Subject: RATTLING NOISE FROM LEFT REAR OF VEHICLE	Bulletin No.: 01-009/19
	Last Issued: 02/13/2019

2019 CX-5 2.5L Turbo vehicles with VINs lower than JM3KE*****514172 (produced before Oct. 27, 2018)
2019 CX-5 2.5L Turbo (Mexico Spec) vehicles with VINs lower than JM3KE*****514172 (produced before Oct. 27, 2018)

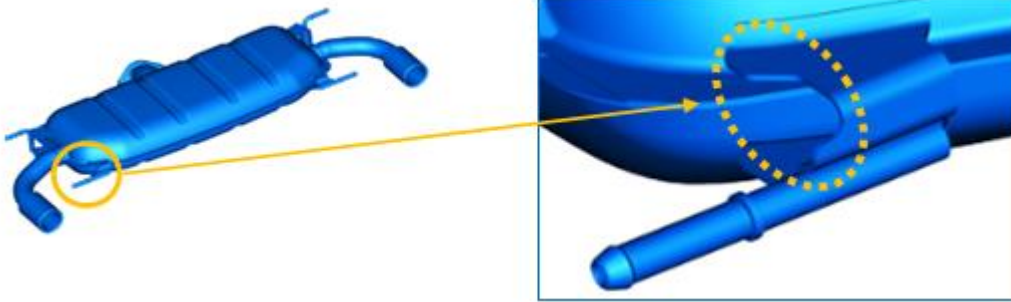
Some customers may notice a rattling noise coming from the left rear of the vehicle while driving on bumpy roads. The noise may be caused by interference between the left rear hanger bracket and the hanger rod, due to a lack of clearance.

The shape of the left rear hanger bracket has been changed.

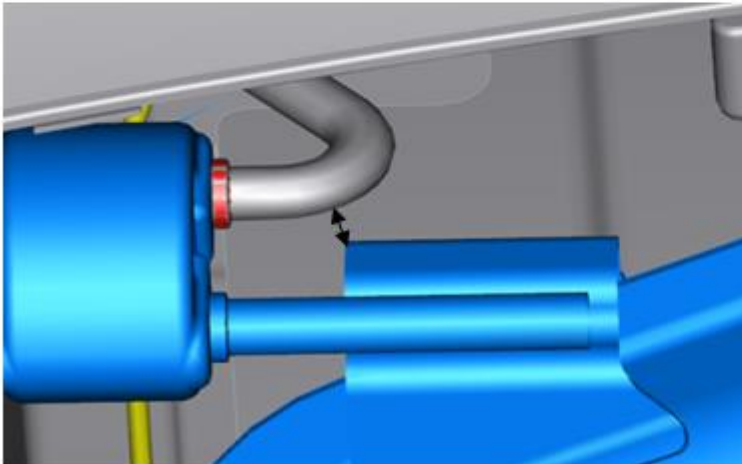
1. Verify the customer concern.
2. Measure the gap between the left rear hanger bracket and the hanger rod.

NOTE: Measure the gap at the narrowest point between the hanger bracket and the hanger rod (as shown above).

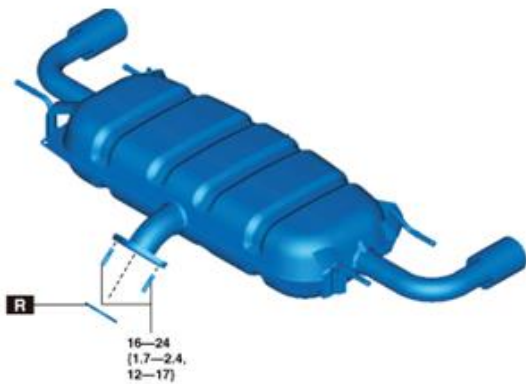
3. Depending on the measurement, take the corresponding action.

- If the gap is 7mm or more, this service information does not apply. Inspect and repair vehicle according to the instructions on MGSS online.

- If the gap is less than 7mm, replace the main silencer with a modified one according to the instructions on MGSS online (EXHAUST SYSTEM REMOVAL/INSTALLATION [SKYACTIV-G 2.5T]).

NOTE: The insulator or remainder of the exhaust system does not need to be removed to replace the silencer. Replace the silencer by removing the two (2) nuts and separating the three (3) rubber hangers from the main silencer.

4. Confirm the clearance is 7mm or more as indicated in Step 2.
